DART AEROSPACE LTD	Work Order:	24297
Description: Arm	Part Number:	D2802-2
Dwg: D2802 rev.A	Qty:	6

DESIGN	DRAWN BY	DART AEROSPACE LTD	
CHECKED	APPROVED	HAWKESBURY, ONTARIO, CANADA	
G	G	DRAWING NO.	REV. A
DATE		D2802	SHEET 1 OF 1
00.11.03		TITLE	SCALE
		ARM	1:3

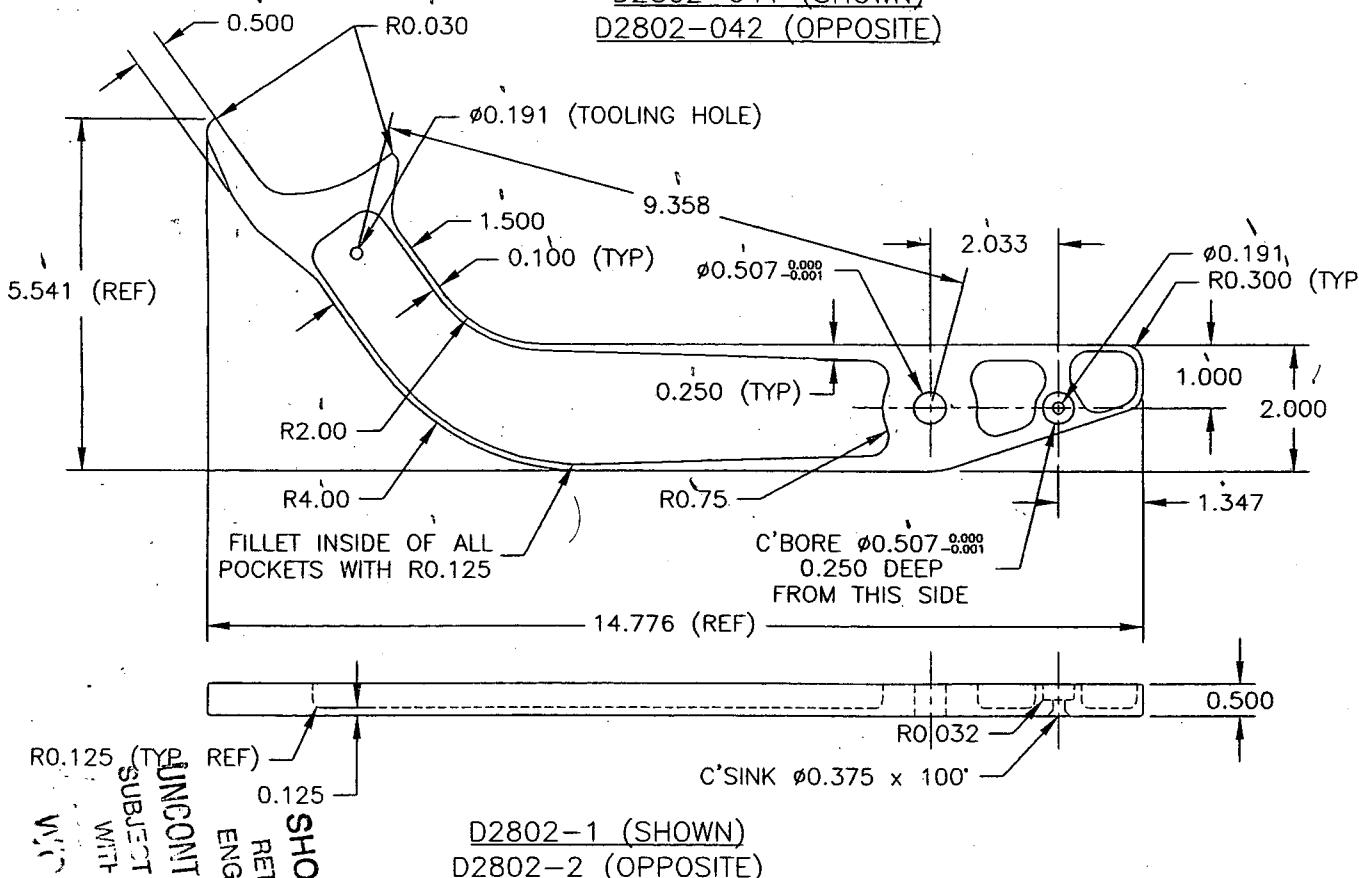
WORK ORDER NON-CONFORMANCE (NCR)						
DATE	STEP	Description of NC Section A	Corrective Action Section B			Verification Section C	Approval Design Mgr	Approval QC Inspector
			Initial Design Mgr	Action Description Design Mgr	Sign & Date			
05.09.19	3	- 1 part scrap did not machine the full profile - error on work order	JB QSI42	- scrap and replace	JL	JB 05.09.20	JB QSI42	18 05.09.20
05.09.19	3	Pivot hole is 0.508" when machined	JP 05.09.19	OK to machine hole $0.507^{+0.001}_{-0.001}$	JP 05.09.27	JP QSI42	JP 05.09.19 per QSI42	18 05.09.27

They are machining D2802-1/-2 arms. The pivot hole is now $0.507+0/-0.001$. They are getting 0.508. The tool program is cutting 0.507 and it's ending up 0.508. They'd have to get Jean-Luc to change the program (not here now). Would a dimension of $0.507+0.001/-0.001$ be allowable?

This is an acceptable deviation. I think it would be a good idea to update the drawing as you proposed for all future parts.
